Office Action Summary

09/725,165

RAMOS ET AL.

DETAILED ACTION

FIG. 17-4 Fluidization regimes. [Adapted from Grace, Can J. Chem. Eng., 64, 353-363 (1986).]

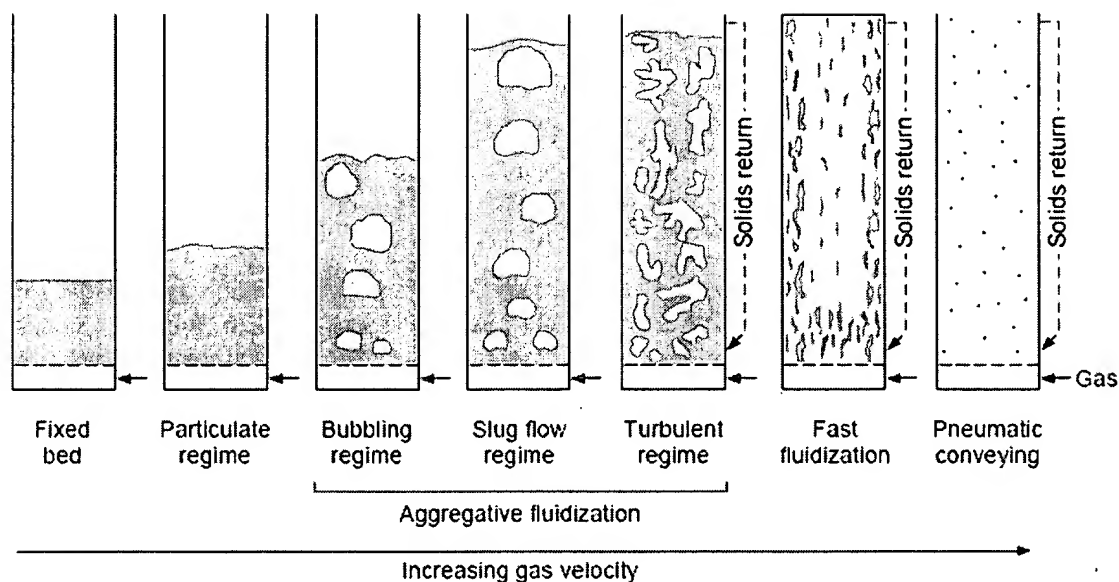
Please note that the newly added limitation of a given level of the fluidized bed of particulates relative to the junction point of the dip leg adds no further patentable weight to the claim because the level of the fluidized bed is merely a recitation with respect to the manner in which the claimed apparatus is intended to be operated, e.g., a process limitation. As is well known in the art of fluidization, for a given amount of solid particulates, the level of the fluidized bed of particulates may vary widely, as a function of the fluidizing gas velocity. Please note the Regime Diagram, attached below. (FIG. 17-4 is taken from Perry's Chemical Engineering Handbook, 7th edition).

FIG. 17-4 Fluidization regimes. [Adapted from Grace, Can J. Chem. Eng., 64, 353-363 (1986).]

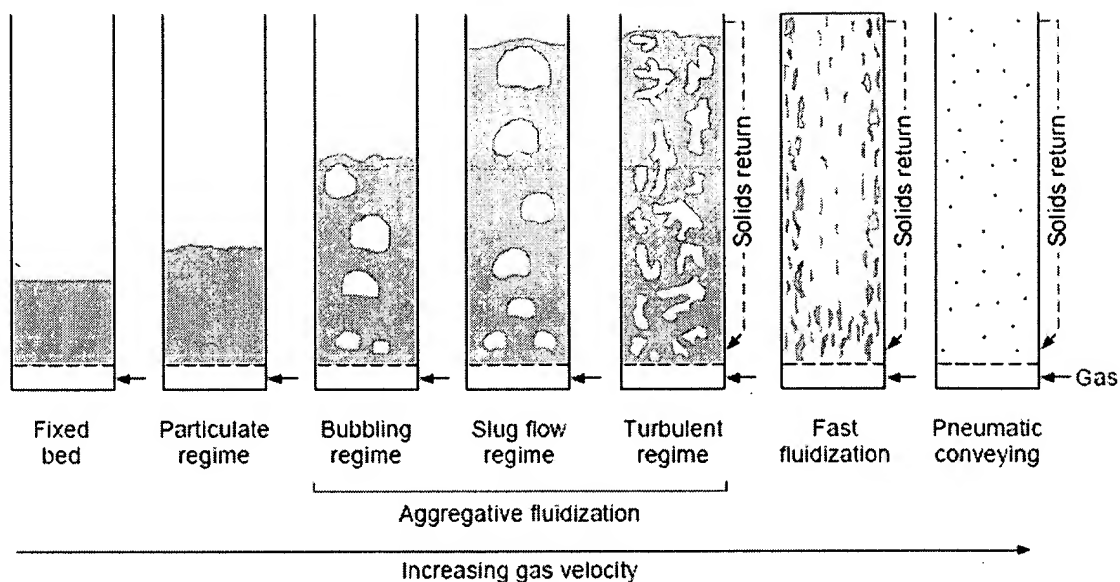
The Examiner respectfully disagrees and maintains that the modified apparatus of Owen et al. structurally meets the claims. The newly added limitation of a given level of the fluidized bed of particulates relative to the junction point of the dip leg adds no further patentable weight to the claim because the level of the fluidized bed is merely a recitation with respect to the manner in which the claimed apparatus is intended to be operated, e.g., a process limitation. As is well known in the art of fluidization, for a given amount of solid particulates, the level of the fluidized bed of particulates may vary widely, as a function of the fluidizing gas velocity. Please note the Regime Diagram, attached below (FIG. 17-4 is taken from Perry's Chemical Engineering Handbook, 7th edition).

As stated in MPEP 2114, the manner of operating a device does not differentiate the device from the prior art. A claim containing a “recitation with respect to the manner in which a claimed apparatus is intended to be employed does not differentiate the claimed apparatus from a prior art apparatus” if the prior art apparatus teaches all the structural limitations of the claim. *Ex parte Masham*, 2 USPQ2d 1647 (Bd. Pat. App. & Inter. 1987) (The preamble of claim 1 recited that the apparatus was “for mixing flowing developer material” and the body of the claim recited “means for mixing ..., said mixing means being stationary and completely submerged in the developer material”. The claim was rejected over a reference which taught all the structural limitations of the claim for the intended use of mixing flowing developer. However, the mixer was only partially submerged in the developer material. The Board held that the amount of submersion is immaterial to the structure of the mixer and thus the claim was properly rejected.)

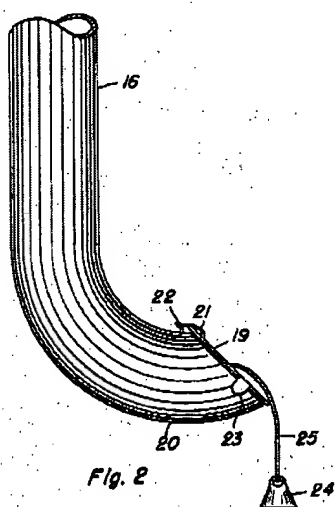
...Luckenbach does not teach that his inclined part is formed from a series of straight pipe section; only a single pipe section is shown forming this component. Likewise, Luckenbach provides no teaching or suggest whatsoever regarding using straight pipe sections to form a radius curve. In fact, if Luckenbach's teachings were followed in Owen/Jones, then Owen/Jones would provide a single straight segment at an incline as depicted in Luckenbach.”

The Examiner respectfully disagrees. The test for obviousness is not whether the features of a secondary reference may be bodily incorporated into the structure of the primary reference; nor is it that the claimed invention must be expressly suggested in any one or all of the references. Rather, the test is what the combined teachings of the references would have suggested to those of ordinary skill in the art. See *In re Keller*, 642 F.2d 413, 208 USPQ 871 (CCPA 1981).

JONES' radius-curved termination

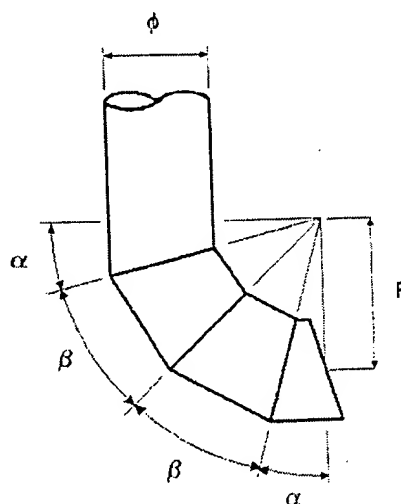
The Examiner respectfully disagrees. It is unclear as to how the radius-curved termination as taught by Jones would differ in function from the radius-curved termination as claimed by Applicants because it appears that the angle of both terminations is essentially the same (please note the attached figures below).

Hence, both the radius-curved terminations of Jones and of Applicants should inherently function similarly or identically, by directing a descending mass flow of dense phase solids into a plane orthogonal to an ascending gaseous flow.
